Friday 23rd April, 2021

Re: Product Change Notification for Harwin packaging.

Left = Previous plastic cap, Right = New metal cap

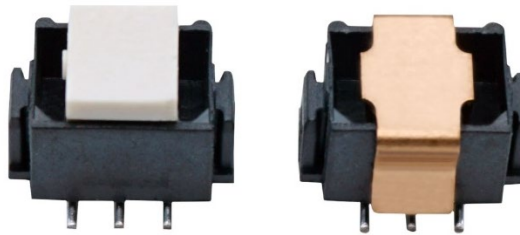
Please be advised that the pick and place cap used on male Datamate connectors (M80 Series) has been changed from a plastic cap to a metal stamped cap. This reverses a previous PCN dated 8th January 2020, following further investigation and improvement of the previous metal cap design.

As you can see from the profiles, a small amount of height has been reduced, and changes to the settings on your pick and place machines may be required.

The connector design itself is unchanged. Please note that we are no longer prepared to supply the plastic cap once stock of the existing packaging is exhausted.
